The site seeking approval for Stage 1 development of a cemetery at 430-490 Douglas Park, Drive Douglas Park, was previously owned by St Mary's Towers Retreat Centre and was separated off from the main property with the redirection of the old Mount Keira Road (now Douglas Park Drive). This process also allowed the creation of a no-through road called Mitchell Place. I believe this to be the reason for the eventual sale of the property in 17/3/1997.

My concerns -

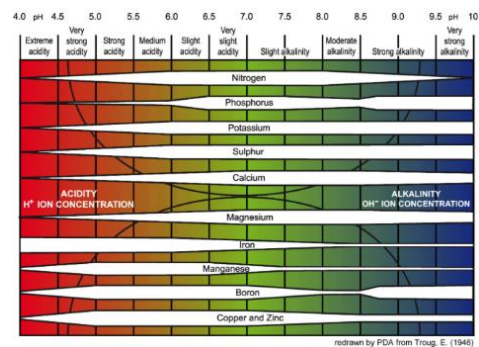
Gypsum does not change the pH. Sulfur is the element needed to lower pH and in reasonably large volumes, which causes a substantial pungent odour and may build up to be detrimental to the soil microbiome. Our native flora relies on the nutrients available at a pH ranging from 5.5- 6.5, and the pH levels of human ashes 9-12 means nothing could grow in that. The two threatened species addressed' *Grevillea parviflora* subsp. *parviflora* and *Persoonia bargoensis* both belong to the *Proteaceae* family. *Proteaceae* species have adapted over time to grow in impoverished soils to produce proteoid roots that seek out phosphorus in the soil. If phosphorus becomes too abundant (as showing on the pH chart in the higher levels), will become toxic and kill them.
